APPLICATION NO.	FILING DATE	FIRST NAMED INVENTOR	ATTORNEY DOCKET NO.	CONFIRMATION NO.
10/723,569	11/26/2003	Wolfgang Beigang	GKNG 1184 PUS	9113

Office Action Summary	Application No.	Applicant(s)	
	10/723,569	BEIGANG, WOLFGANG	
	Examiner	Art Unit	
	Lan Nguyen	3683

DETAILED ACTION

FIG. 6

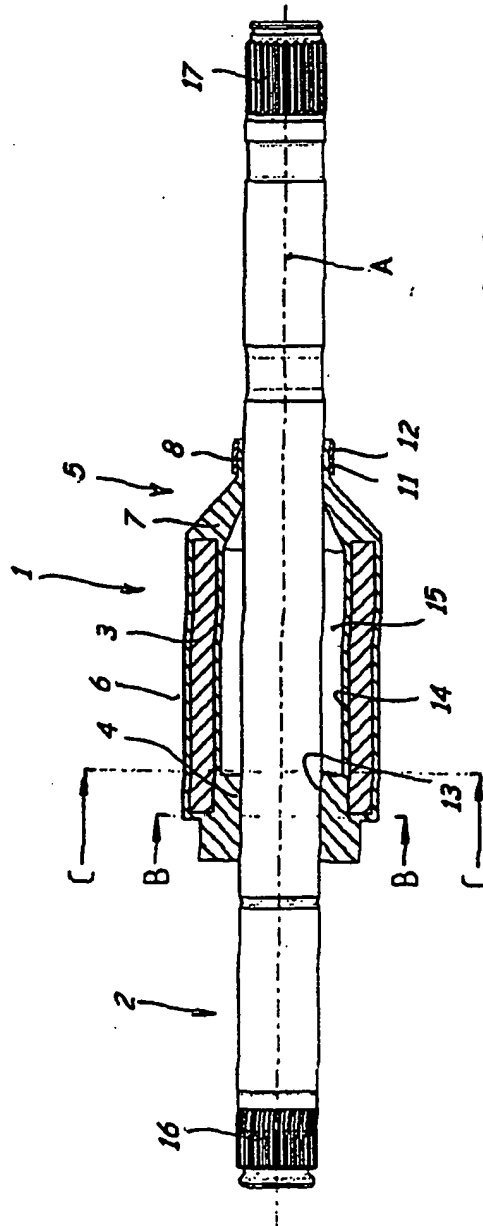
1. The drawings of figures 6-8, submitted 8/5/05, have been approved.

9. Applicant's arguments filed 8/5/05 have been fully considered.
- Applicant's argument regarding the rejections under 112, 1st paragraph and 112, 2nd paragraph have been found persuasive. The rejections have been withdrawn. The new drawings of figures 6-8 and the amendments to the specification have been approved.
